Wendlebury Road, Bicester

Road Safety Audit
Stage 1

23 May 2019

Figure 1: Existing ditch on southern side of Wendlebury Road.

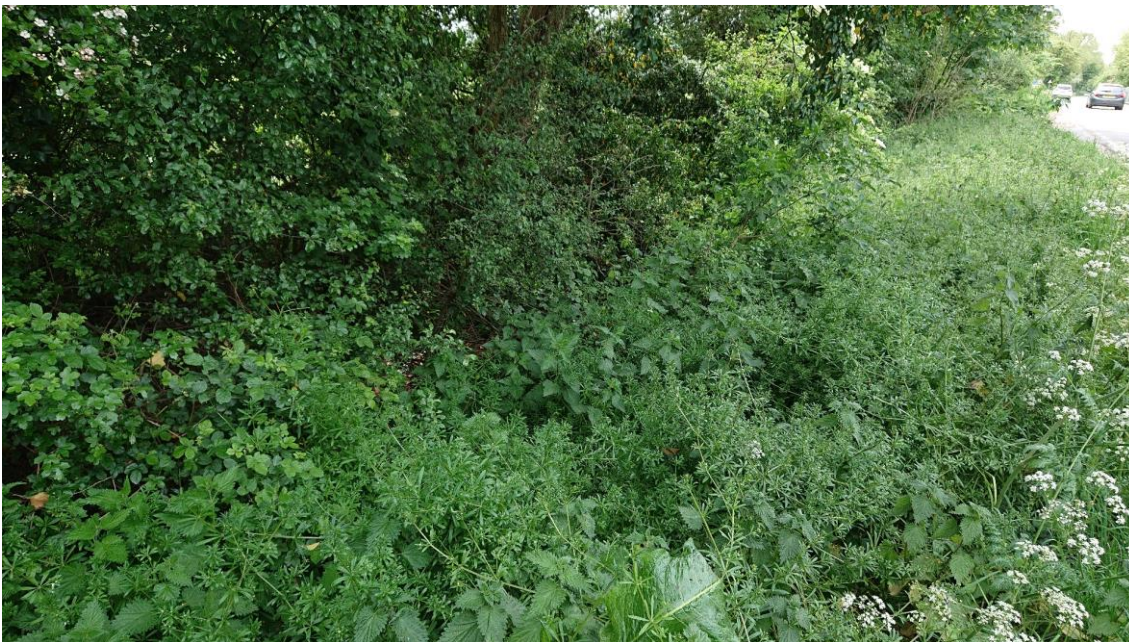
Location: Southern side of Wendlebury Road.

Summary: Drop at back of footway may present a hazard to pedestrians.

A new 2.5m footway / cycleway is proposed along the southern side of Wendlebury Road. There is an overgrown ditch running the length of Wendlebury Road throughout the scheme, with a noticeable level difference from the carriageway level to the bottom of the ditch. Provision of a footway at this location will result in drop at the back of the footway, which may present a hazard to pedestrians or cyclists should they leave the paved surface. This may result in falls resulting in personal injury.

It is recommended that a fence or guardrail is provided at the back of the footway wherever a drop to surrounding surface levels is present. Alternatively, ground at the back of the footway should be graded to avoid a steep drop.

B. Key Plan – Wendlebury Road, Bicester

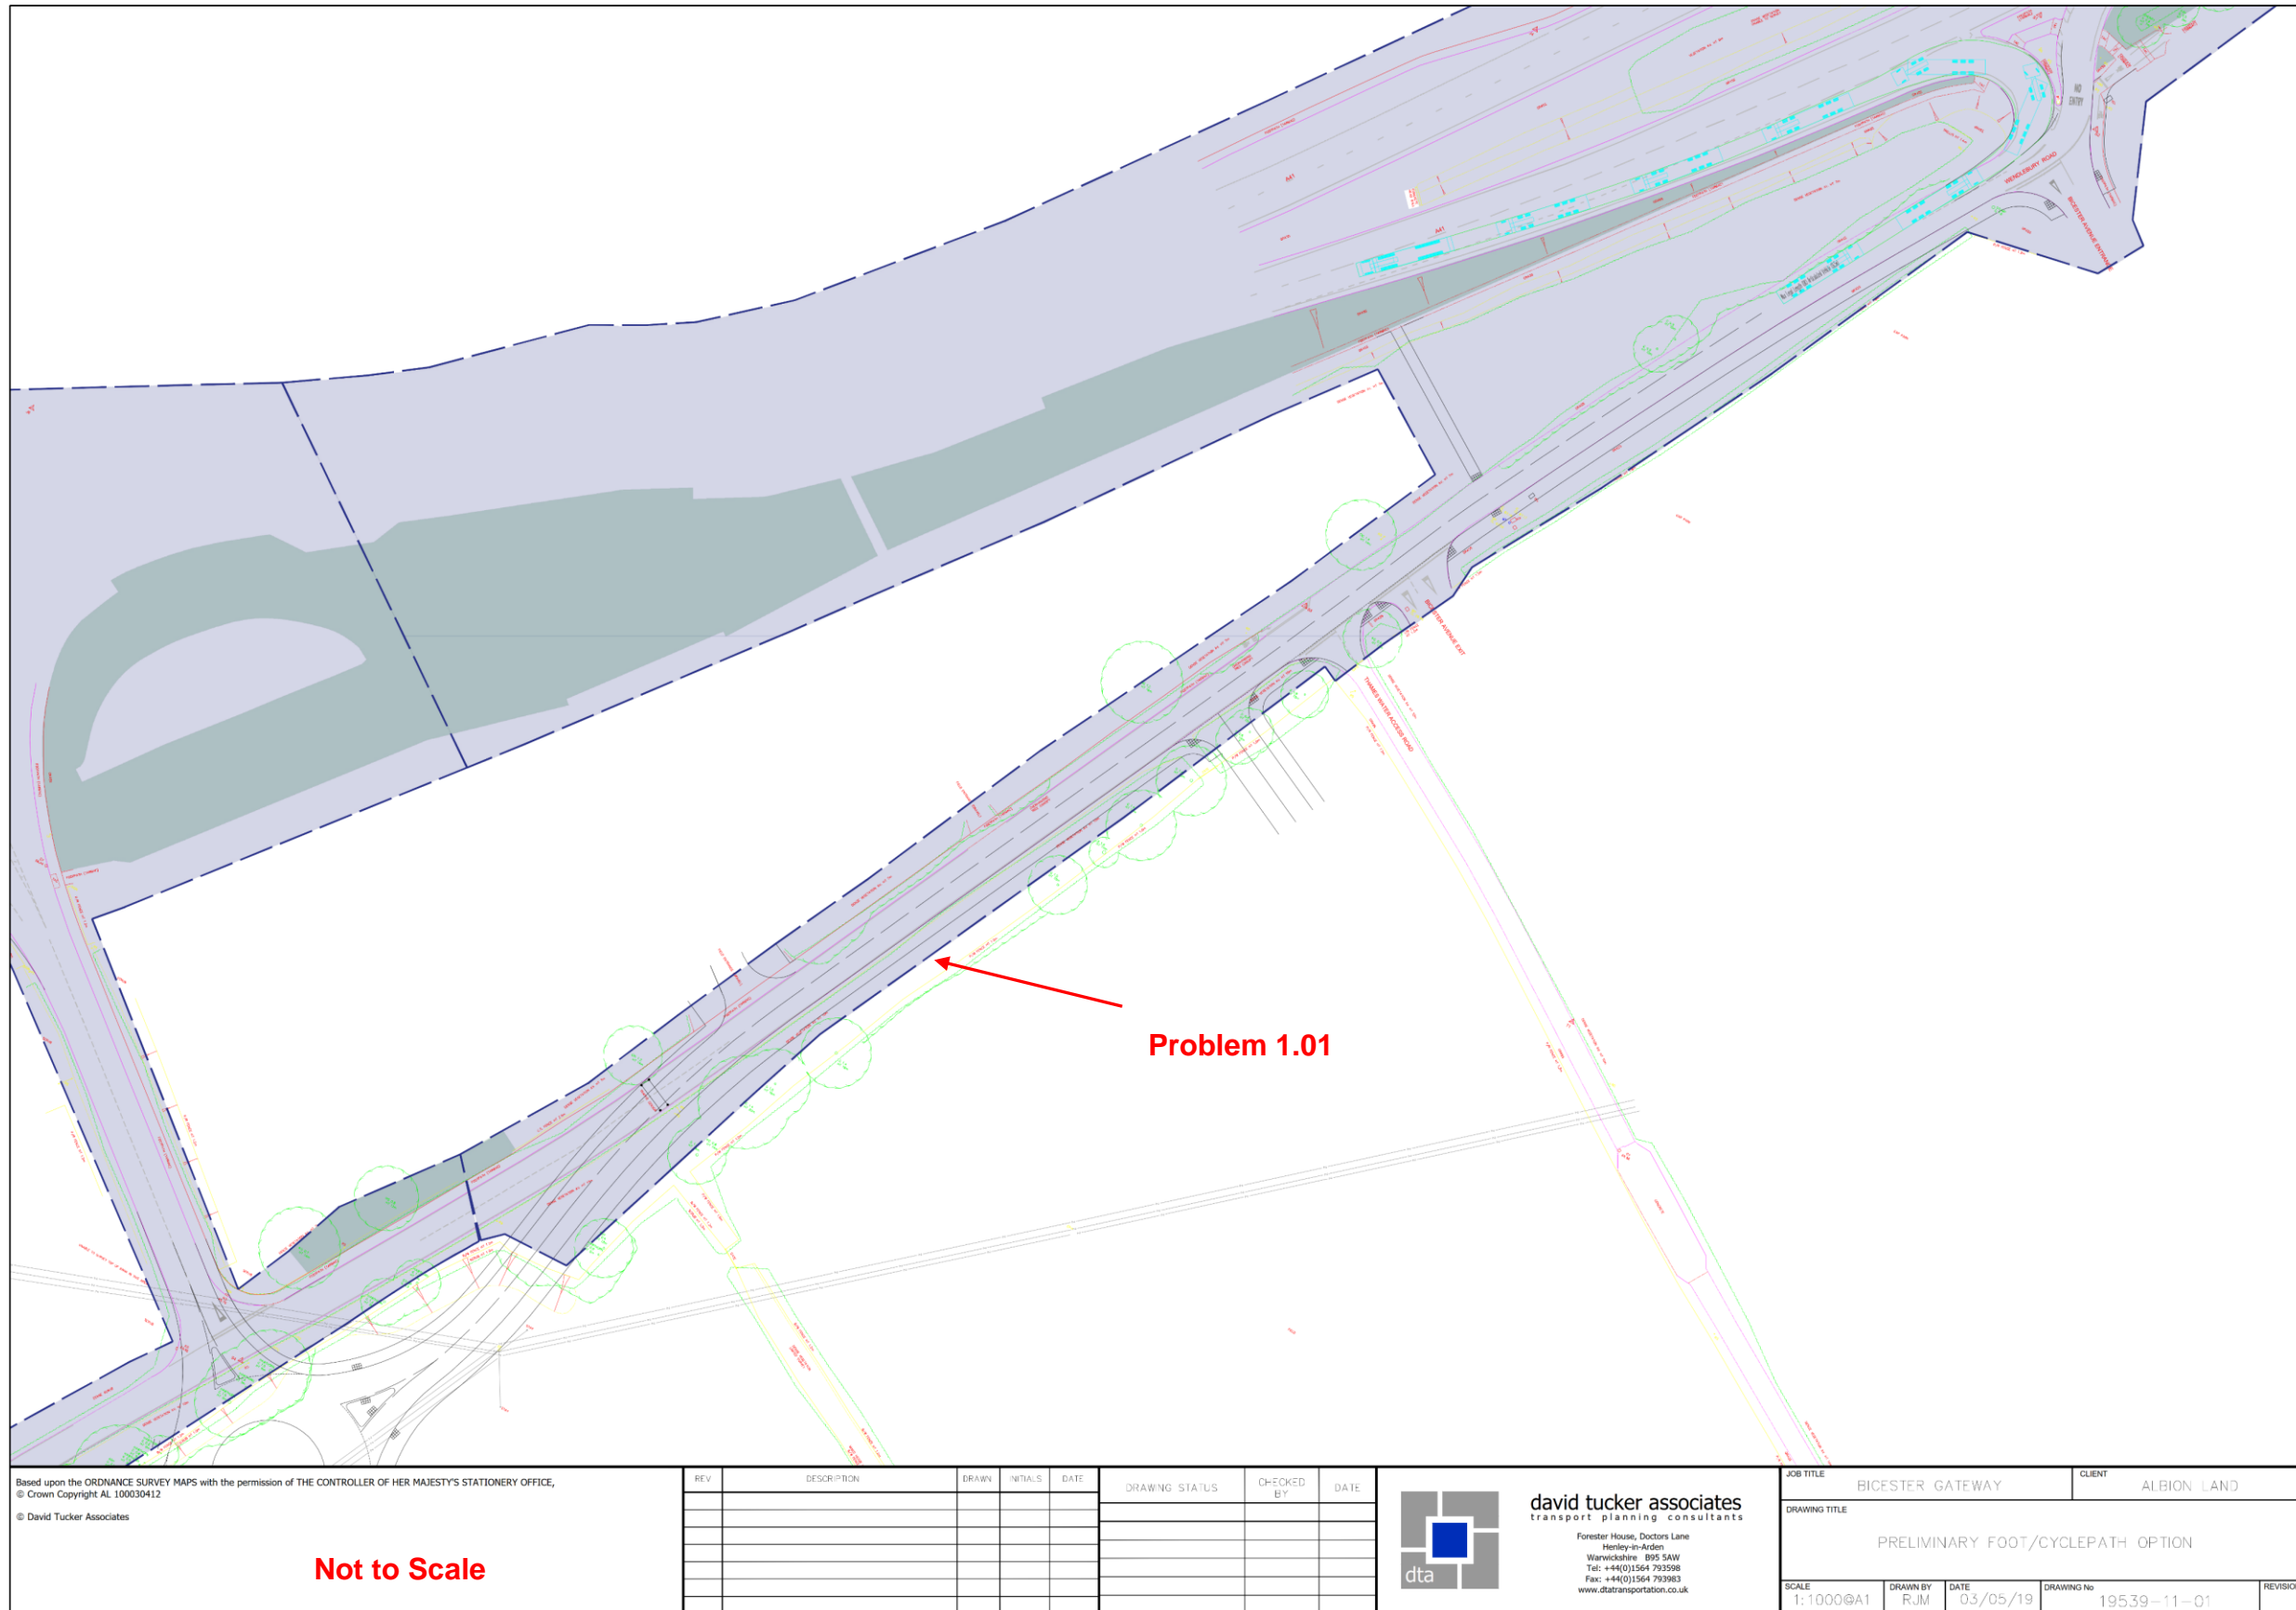
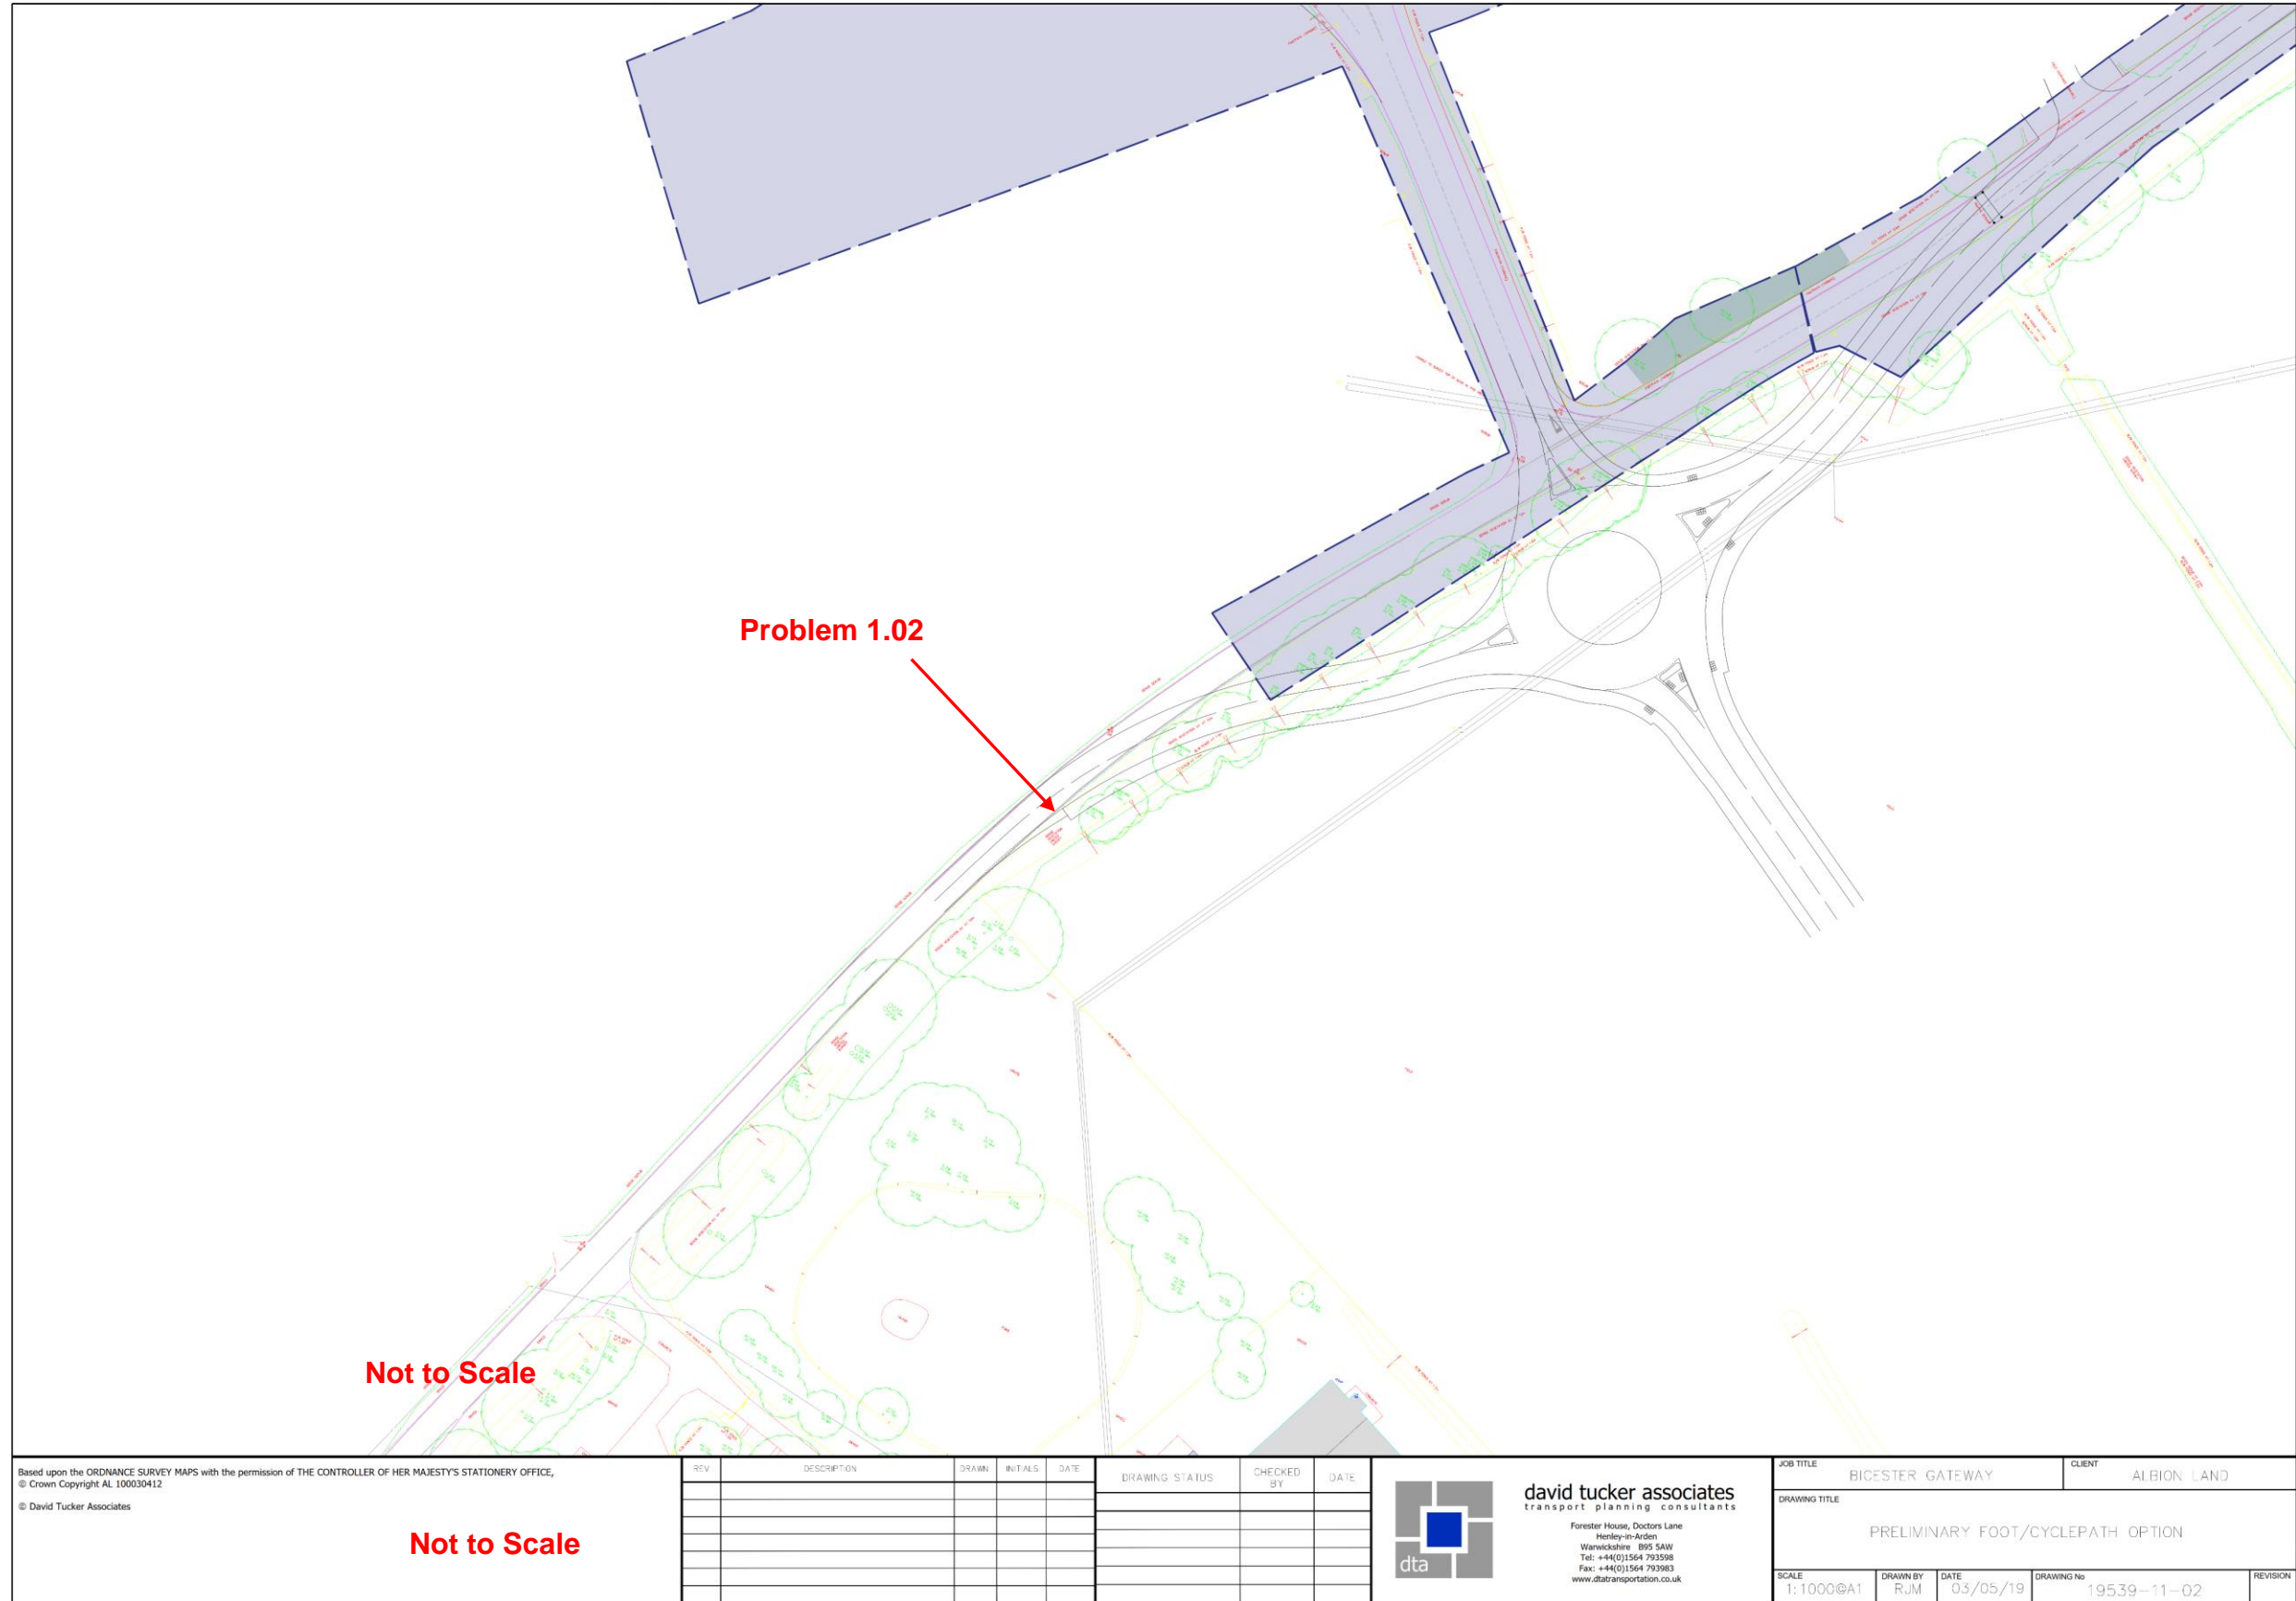
Location: Wendlebury Road – western extent of scheme.

Summary: Unclear end of footway / cycleway.

A new 2.5m footway / cycleway is proposed along the southern side of Wendlebury Road. It is proposed that this will continue to the west of the proposed roundabout, but there are no existing footway / cycleway provisions on this side of the junction. It is unclear if there will be a demand in this direction and therefore the continuation of the footway / cycleway may encourage users continuing to the west to enter the carriageway increasing their vulnerability to being struck.

It is recommended that appropriate tie-ins with surrounding facilities are provided. If no pedestrian / cyclist demand is anticipated in this direction, the footway / cycleway to the west of the roundabout should be omitted from the scheme.
